SUBJECT: ST. LUCIE PLANT, UNIT 2 - ISSUANCE OF AMENDMENT REGARDING NEW  
FUEL VAULT AND SPENT FUEL POOL NUCLEAR CRITICALITY ANALYSIS  
(TAC NO. ME8782)

Amendment No. 162  
Renewed License No. NPF-16

SAFETY EVALUATION BY THE OFFICE OF NUCLEAR REACTOR REGULATION

ST. LUCIE PLANT, UNIT NO. 2

**FIGURE 5.6-1**  
**Allowable Region 1 Storage Patterns and Fuel Arrangements**

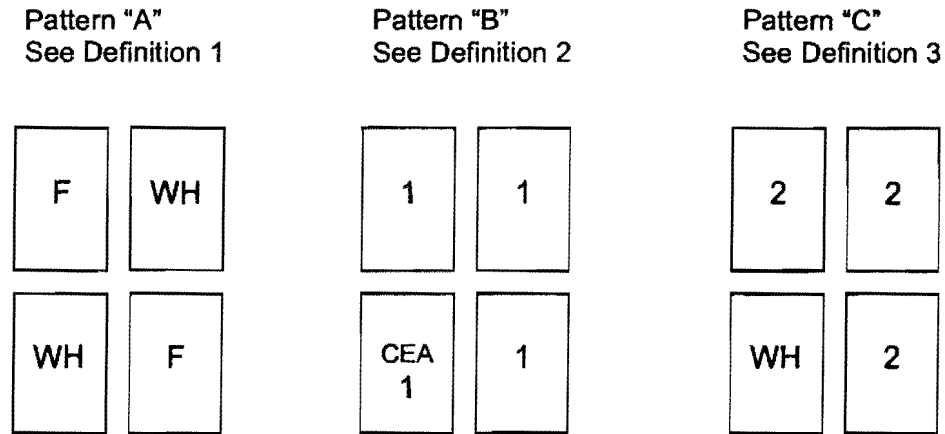
2. Fuel placed in Region 1 of the spent fuel pool storage racks shall comply with the storage pattern definitions of Figure 5.6-1 and the minimum burnup requirements as defined in Table 5.6-1. (See Specification 5.6.1.c.7 for exceptions)

1. Allowable pattern is fresh or burned fuel checkerboarded with completely water-filled cells. Diagram is for illustration only, where F represents Fuel and WH represents a completely water-filled cell.
2. Allowable pattern is placement of fuel assemblies that meet the requirements of type 1 in each 2x2 array location with at least one full-length full-strength CEA placed in any cell. Minimum burnup for fuel assembly type 1 is defined in Table 5.6-1 as a function of maximum initial planar average enrichment. Diagram is for illustration only.
3. Allowable pattern is placement of fuel assemblies that meet the requirements of type 2 in three of the 2x2 array locations in combination with one completely water-filled cell. Minimum burnup for fuel assembly type 2 is defined in Table 5.6-1 as a function of maximum initial planar average enrichment. Diagram is for illustration only.

**FIGURE 5.6-3 (Sheet 1 of 2)**  
**Interface Requirements between Region 1 and Region 2**

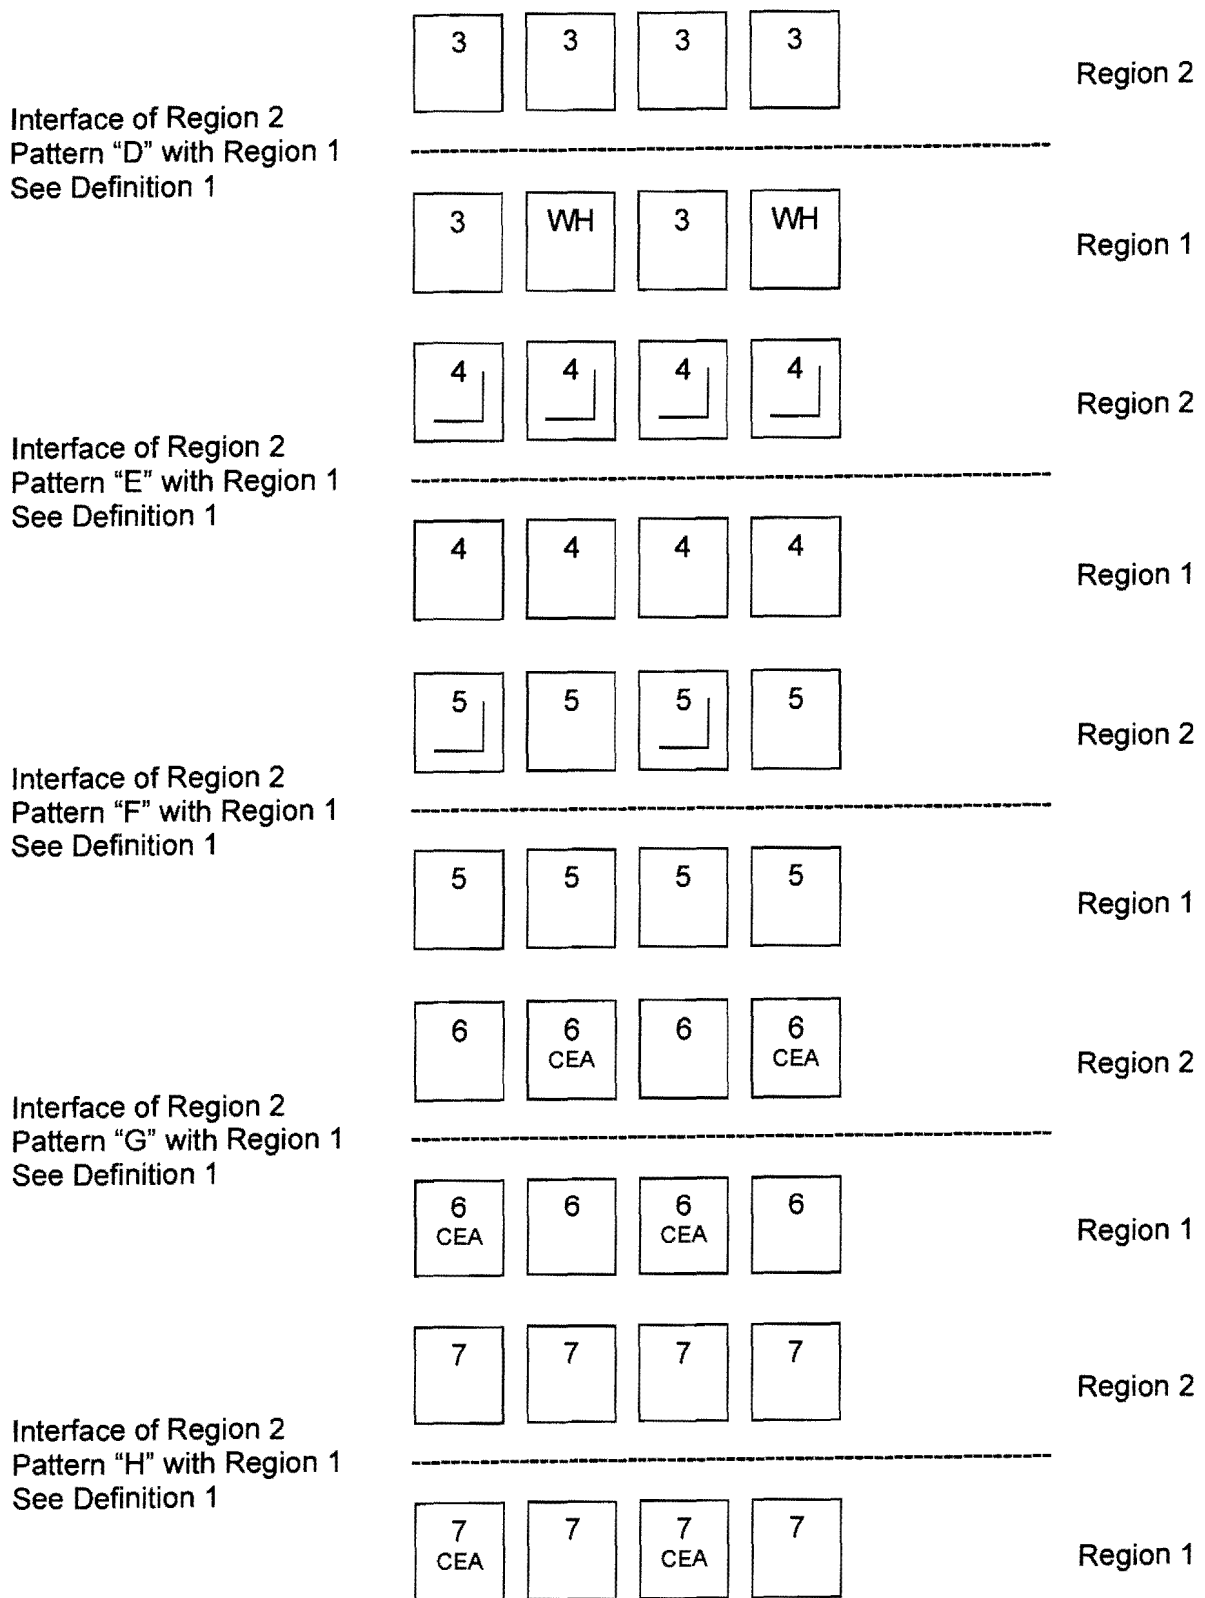
4. The 2x2 array of fuel assemblies that span the interface between Region 1 and Region 2 of the spent fuel pool storage racks shall comply with the storage pattern definitions of Figure 5.6-3 and the minimum burnup requirements as defined in Table 5.6-1. The allowed special arrangements in Region 2 as shown in Figure 5.6-2 shall not be placed adjacent to Region 1. (See Specification 5.6.1.c.7 for exceptions)

1. Each 2x2 array that spans Region 1 and Region 2 shall match one of the Region 2 allowable storage patterns as defined by Specification 5.6.1.c.3. Any required Metamic inserts must be placed into the fuel assemblies in Region 2. Locations of completely water-filled cells or CEAs may be in either Region 1 or Region 2. For interface assemblies, the requirements of Specifications 5.6.1.c.2 and Specification 5.6.1.c.3 shall be followed within Region 1 and Region 2, respectively. The Diagrams are for illustration only.

**FIGURE 5.6-4**  
**Allowable Cask Pit Storage Rack Patterns**

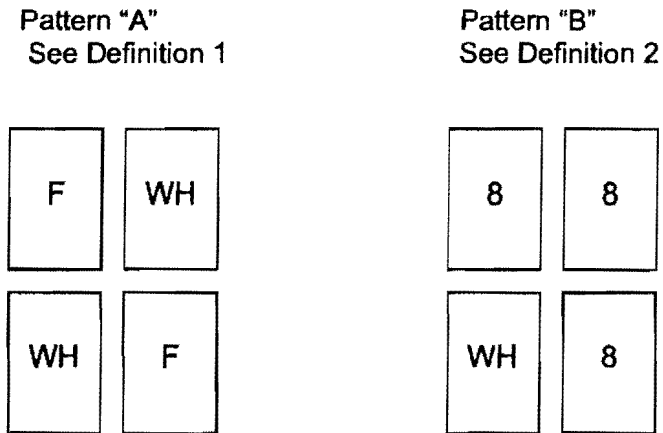
5. Fuel placed in the cask pit storage rack shall comply with the storage pattern definitions of Figure 5.6-4 and the minimum burnup requirements as defined in Table 5.6-1. (See Specification 5.6.1.c.7 for exceptions)

1. Allowable pattern is fresh or burned fuel checkerboarded with completely water-filled cells. Diagram is for illustration only, where F represents Fuel and WH represents a completely water-filled cell.
2. Allowable pattern is placement of fuel assemblies that meet the requirements of type 8 in three of the 2x2 array locations in combination with one completely water-filled cell in any location. Minimum burnup for fuel assembly type 8 is defined in Table 5.6-1 as a function of maximum initial planar average enrichment. Diagram is for illustration only.
